Re: Explanation of Modifications for:
1950 East Logan Street,
Philadelphia, PA.

Civic Design Review Comments:

1950 East Logan Street

TOPOGRAPHIC SURVEY AND PLAN

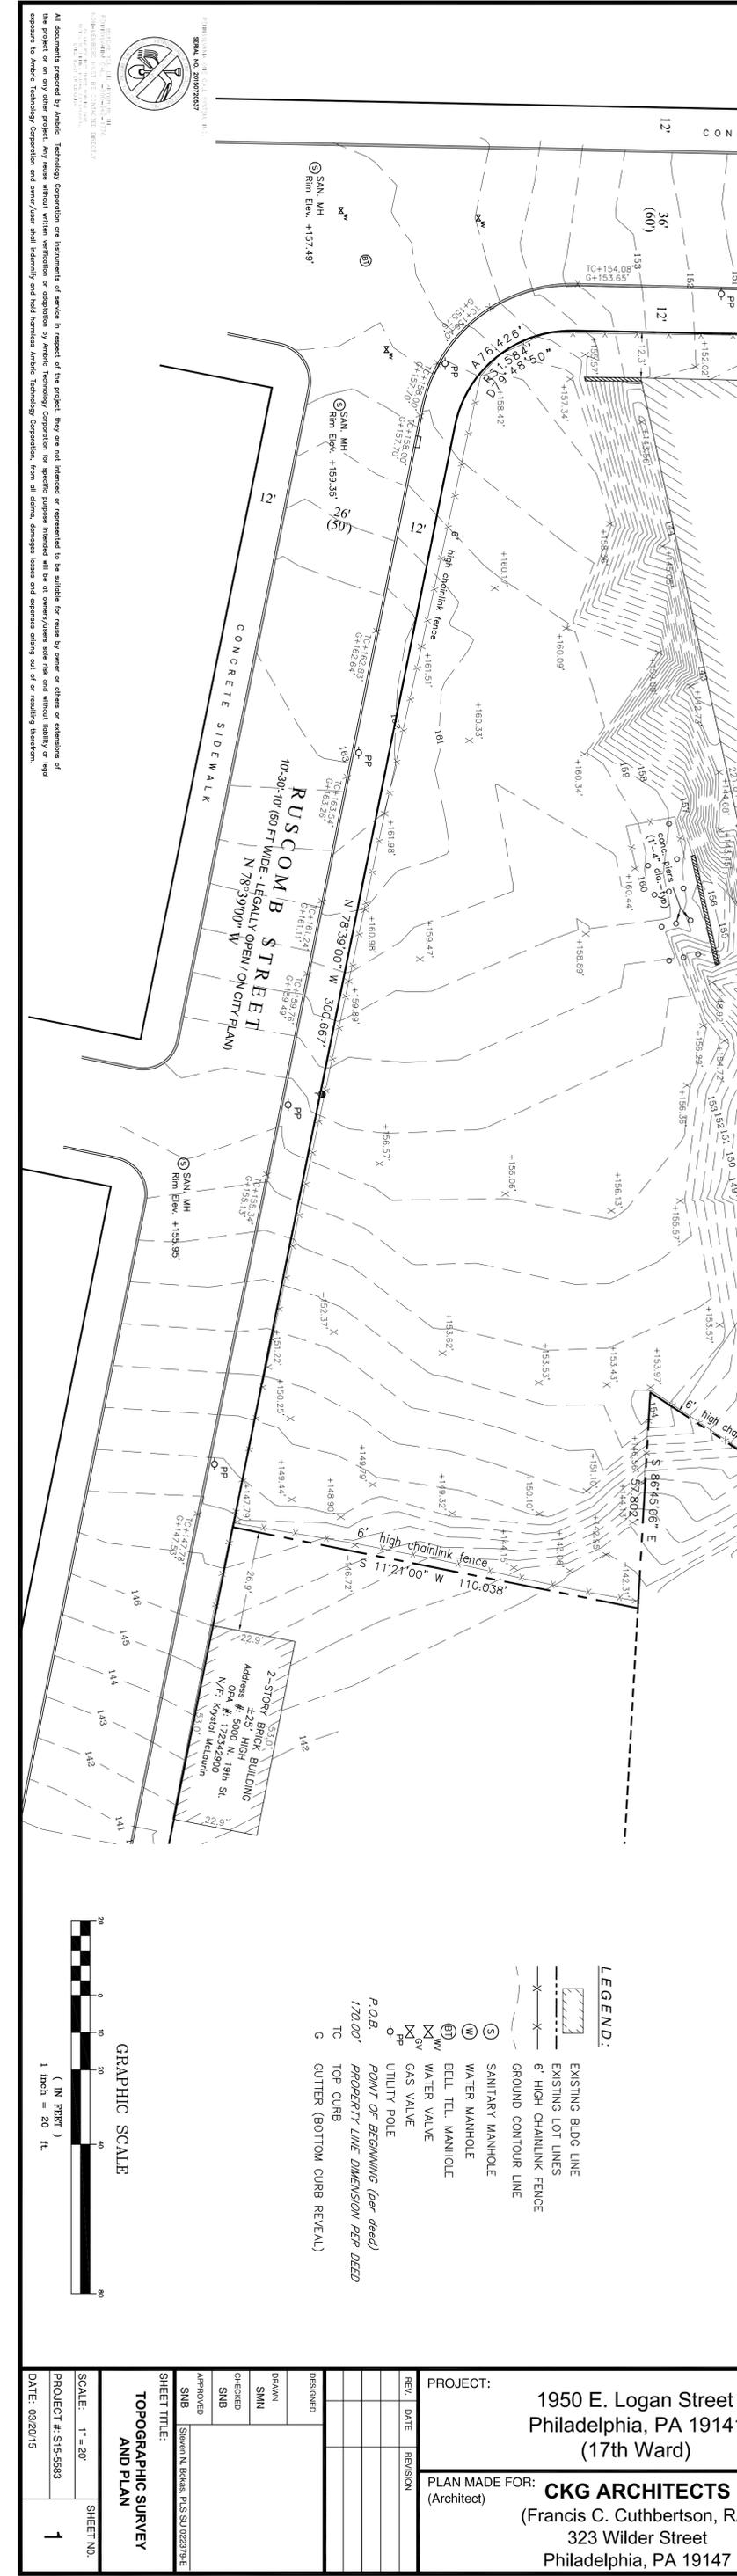
- 10.) Site drainage is a possible issue because of the sloped site. *-Please review the site topography plan #1 in the attached drawing set, which was completed by Ambric Technology Corp. who will be performing the Civil Engineering civil engineering duties for this project, including designing the project to have proper drainage as per code.*

Project: 1950 EAST LOGAN STREET
Drawing Title: SITE PLAN
Drawing Number: **A001**

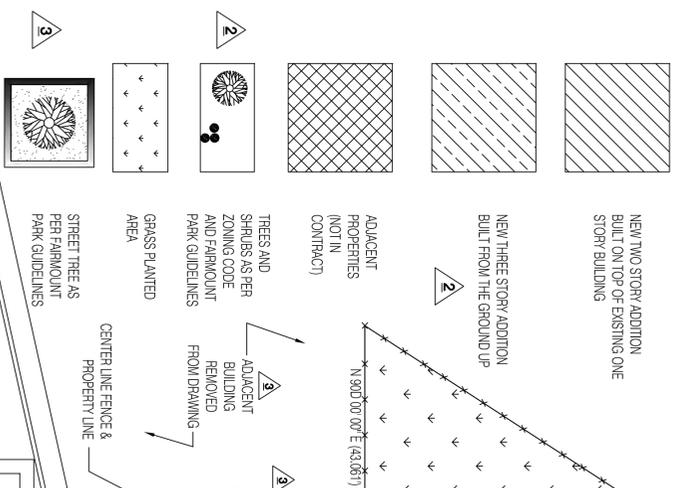
- 1.) Consider removing the fence, or sections of the fence especially near the entrance at Logan Street. *–Please review the site plan A001 which shows the removal of the fence along East Logan Street from the intersection of East Logan and Twentieth Street, up to the parking lot.*

- 2.) Consider adding a community amenity, such as allowing the community into the open, green space or adding a play area. *- Please review the site plan A001 which shows the added community play area at the intersection of Ruscomb and Twentieth Streets.*

- & A3.5 which shows the refined apartment unit layouts, and enlarged elevator lobby areas on all four levels.*
- 6.) Sidewalks need to be more generous. *- Please review the site plan A001 which shows the wider sidewalks on Logan, 20th and Ruscomb Streets.*

- 1.) The walking zone for this project is inadequate. 4'-0" on North 20th Street is not enough walking zone, especially because of the existing telephone pole placement in the middle of the sidewalk. 4'-0" on Ruscomb Street is not acceptable because there is currently no existing sidewalk and the expectation is that there will be a sidewalk network connection constructed, so the suggestion to have 6'-0" wide sidewalks around the entire project is logical. *-Please review the Site Plan A001 which notes the wider sidewalks as suggested.*

- 2.) The two curb cuts that will not be used on Logan Street must be removed to reinstate the typical curbed sidewalk. *-Please review the Site Plan A001 which notates the removal of the aforementioned curb cuts.*

- 4.) The additional lighting needs to be specified. Lighting along the internal pedestrian path to Ruscomb needs to be incorporated into the design for pedestrian safety. *-Please review the Site Plan A001 which shows the added lighting along the aforementioned pedestrian path.*

- 4.) The parking lot could be setback to match the building line along Logan Street. This supports the design intent to make the Logan Street elevation the front façade, and may also solve the refusal for parking in the front yard.-*Please review the Site Plan A001 which shows the parking lot setback is now aligned with the Logan Street building façade.*

Project:	1950 EAST LOGAN STREET
Drawing Title:	ELEVATIONS
Drawing Number:	A2.0

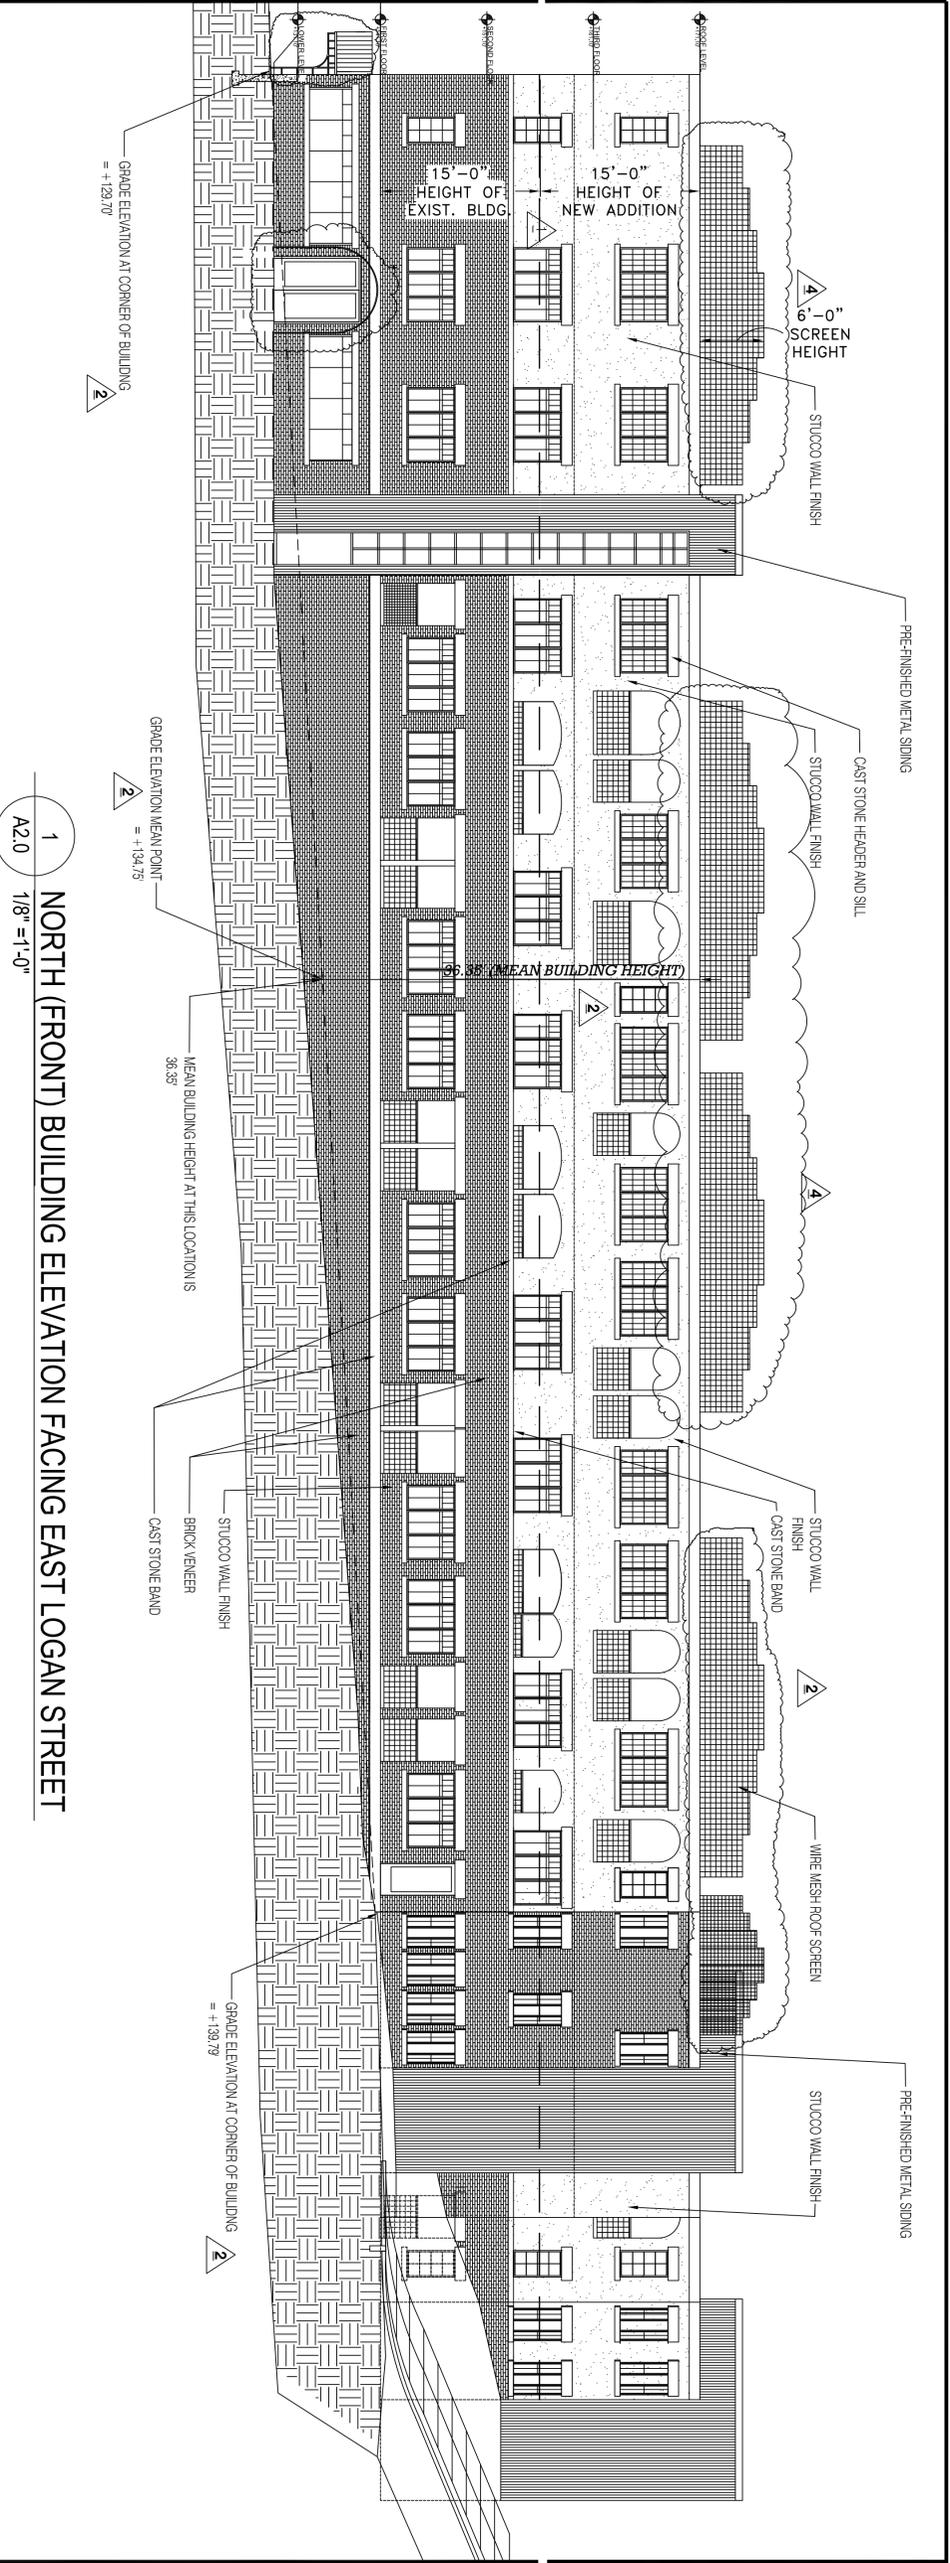
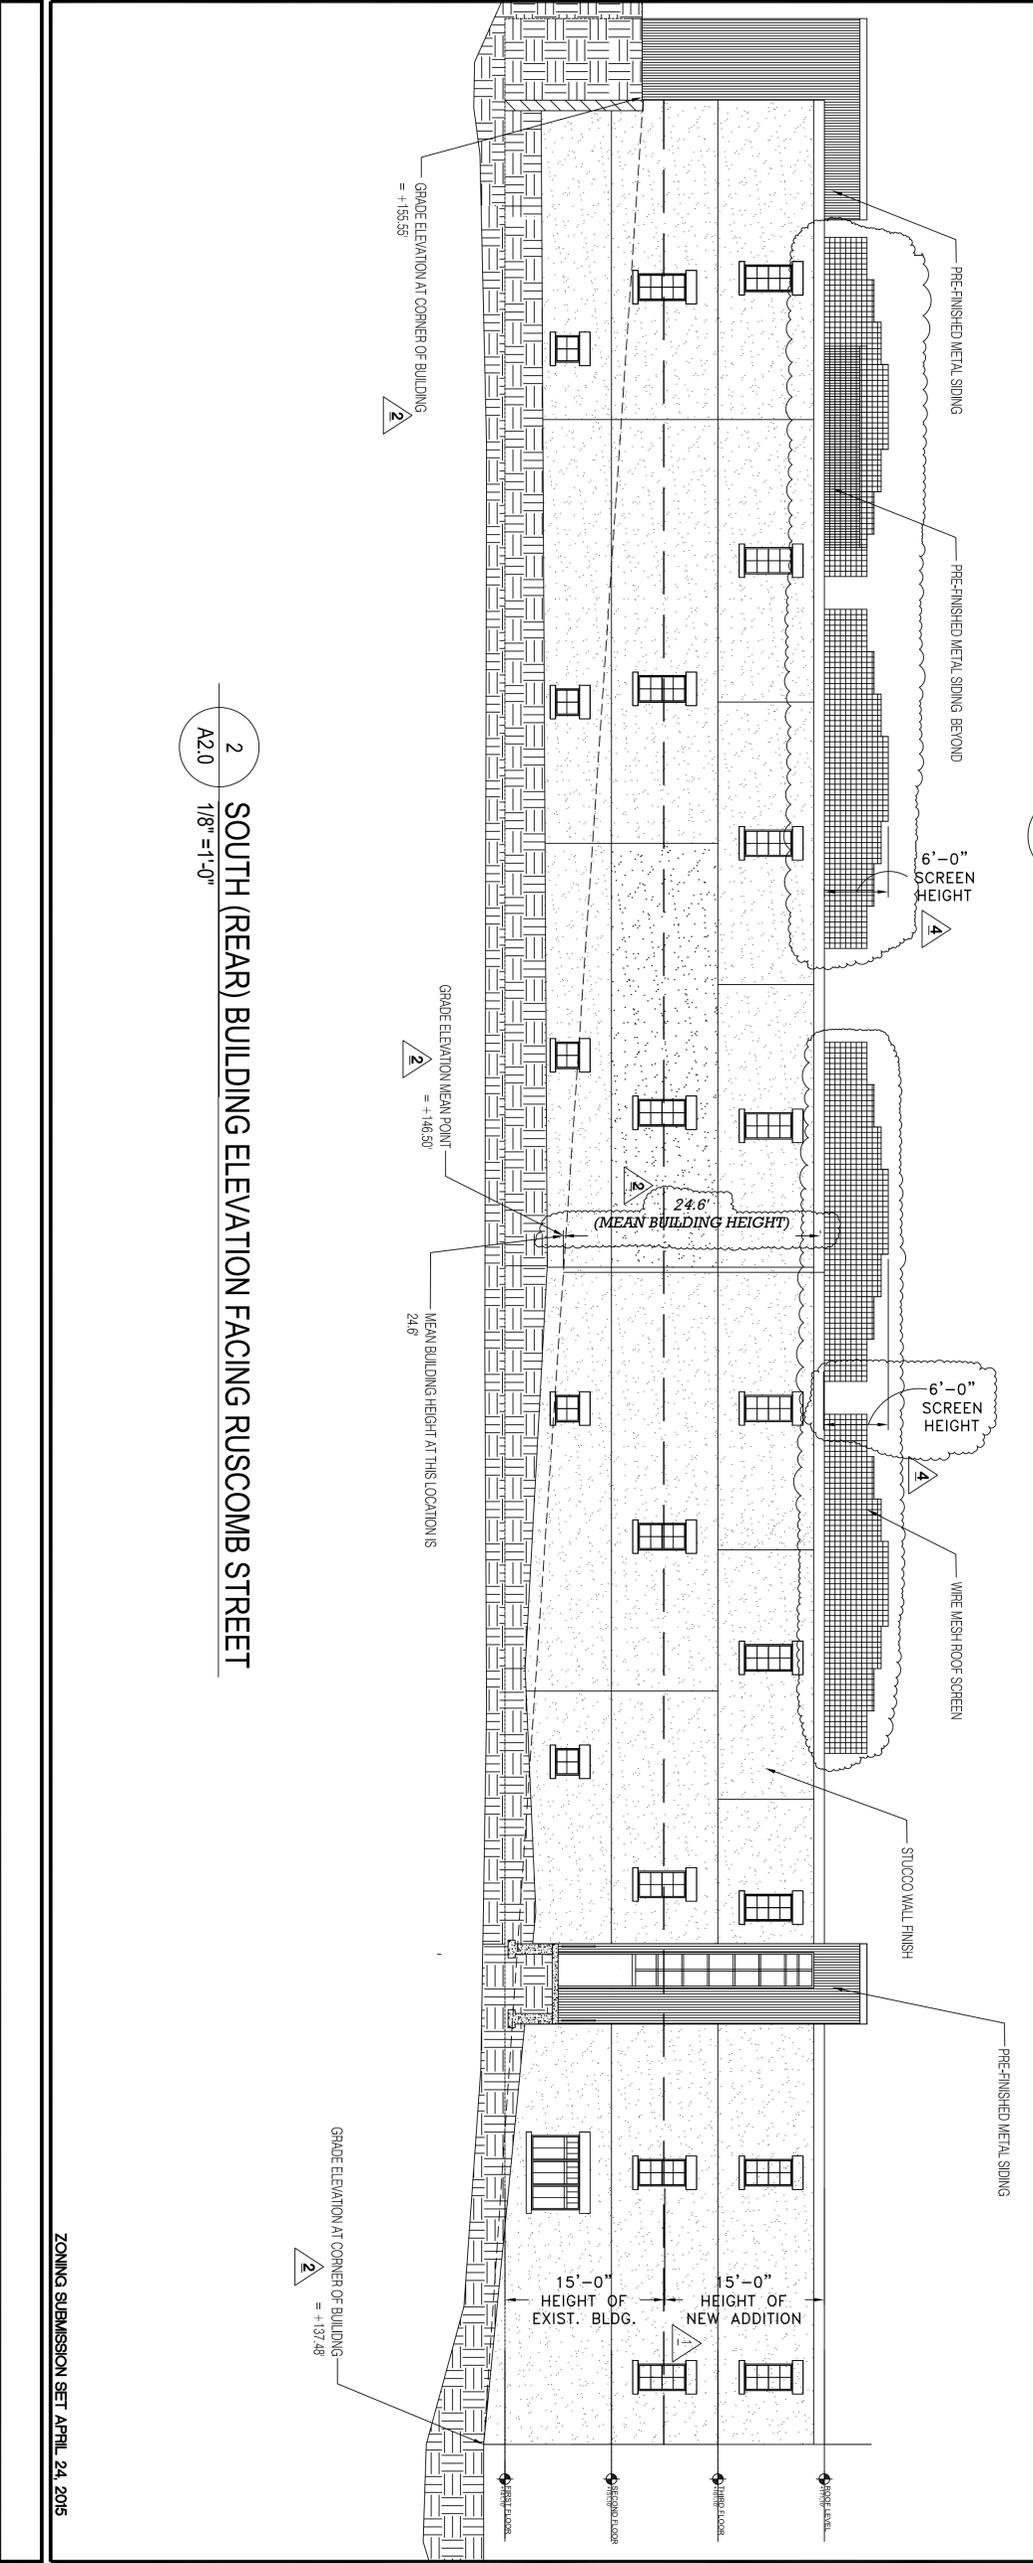
- 3.) The curvy roof top mechanical screens are inconsistent with the industrial aesthetic of the building.-*Please review elevation and section drawings A2.0, A2.1 and A3.0 which show the rooftop mechanical screens as a more orthogonal roof element.*

A3.0

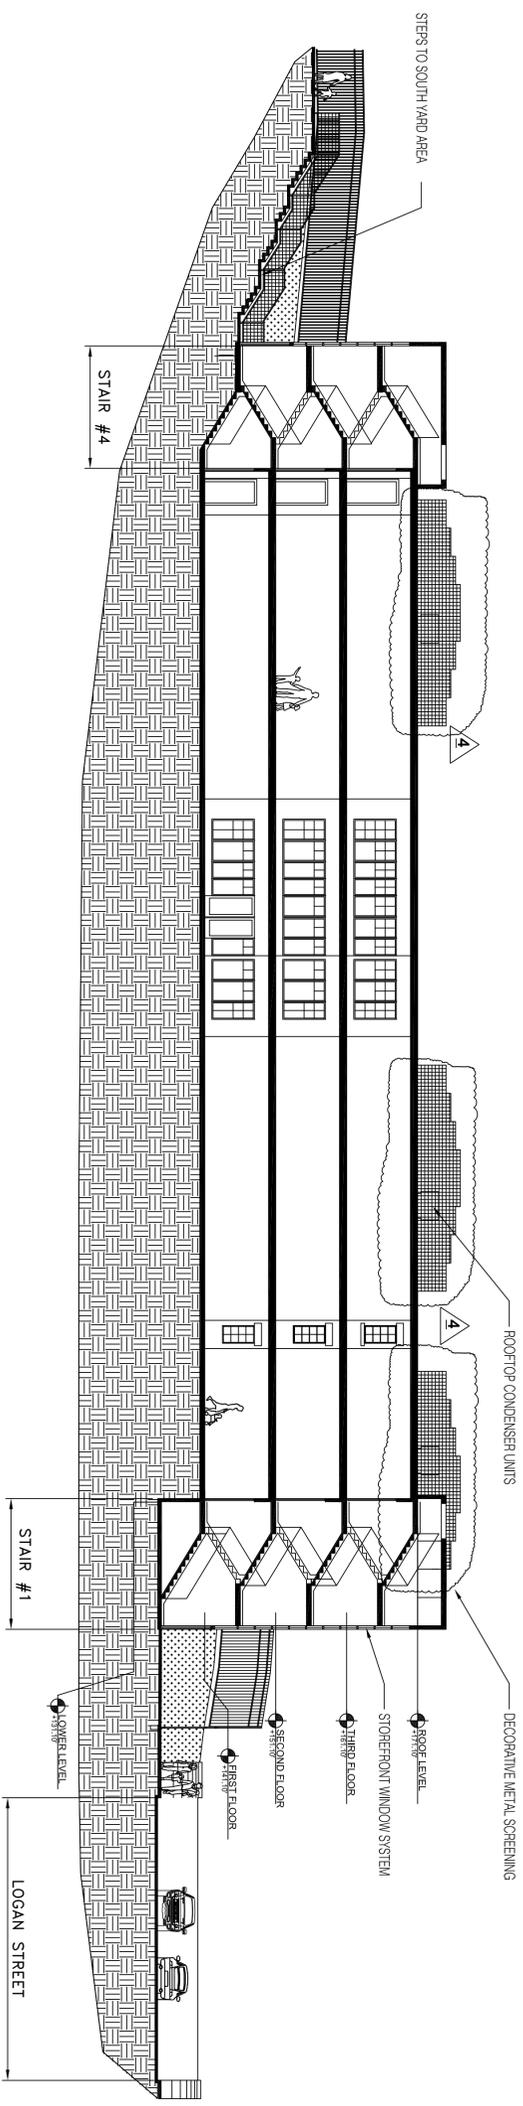
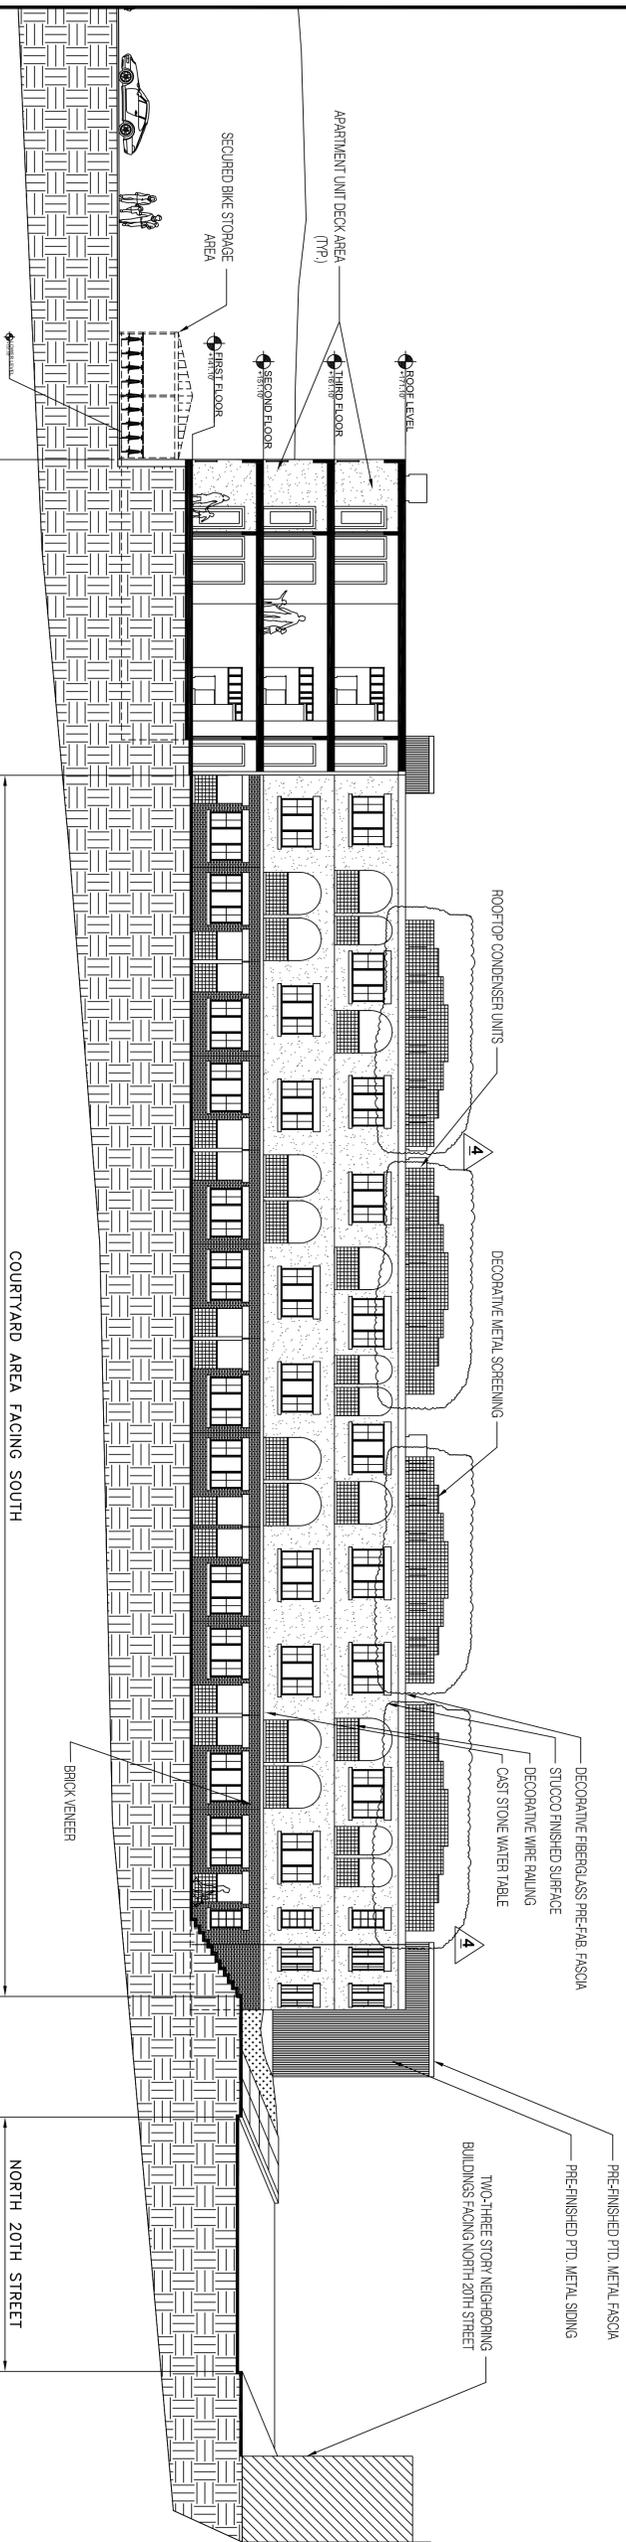
- 11.) Exterior materials and mechanical screening needs further design consideration. *- Please review the attached drawings A2.0, A2.1, A3.0, and the renderings which show the modifications to the rooftop screening design.*
